Reference: NHTSA Identification Number 07V-414

Safety Recall G33

Front Door Latch Cables

2007 - 2008 (JS) Dodge Avenger and Chrysler Sebring Convertible

Figure 3

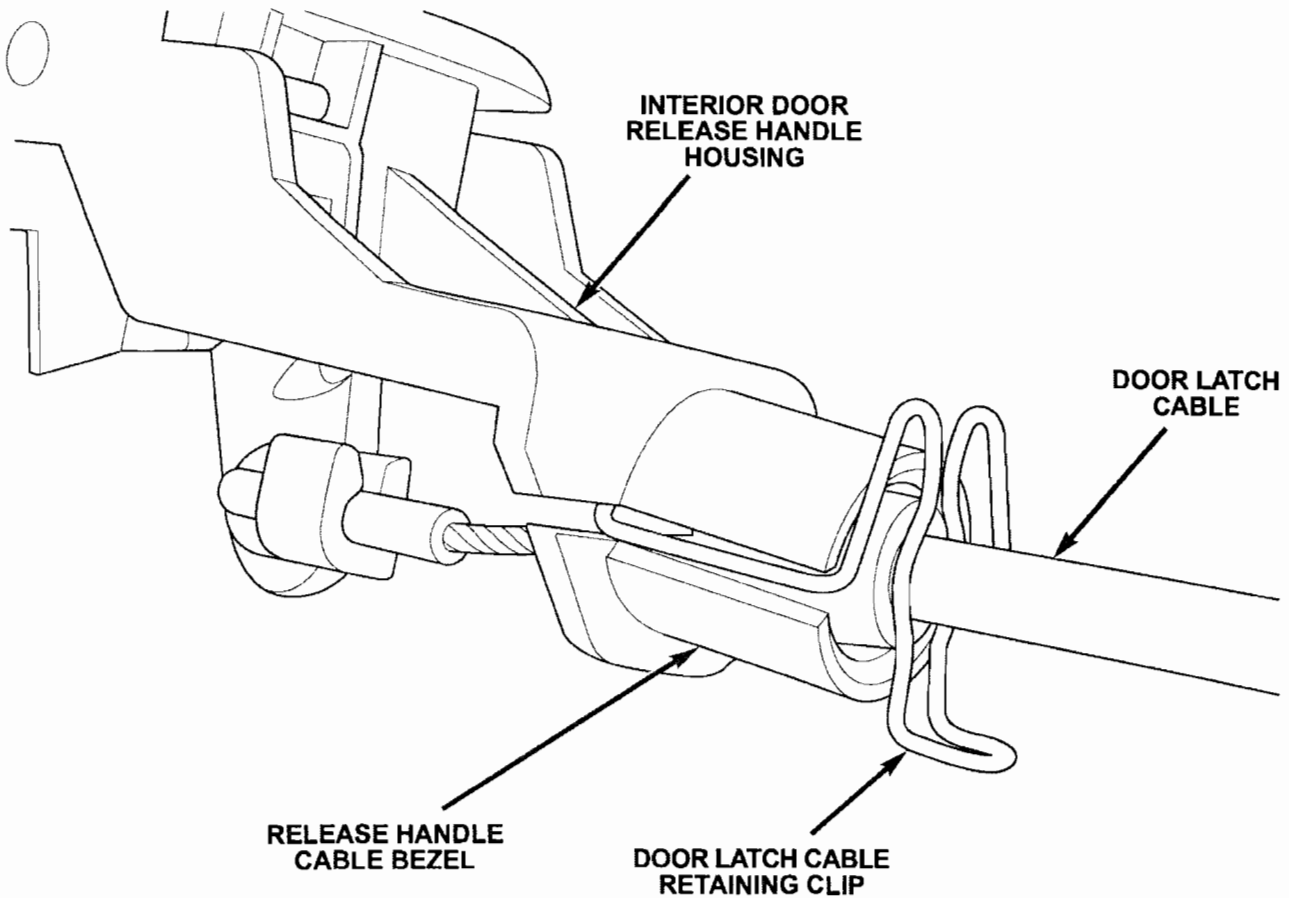
A latch cable retaining clip must be installed on the right and left front door interior release handle housings.

9. Install one interior door latch cable retaining clip as shown in Figure 3.
10. Verify that the door latch cable is snapped into the cable retainer clip and then install the door trim panel to the door (Figure 4).
11. Install the two pull cup retaining screws (Figure 1).
12. Install the door pull cup screw cover (Figure 1).
13. Install the interior door release handle retaining screw (Figure 1).
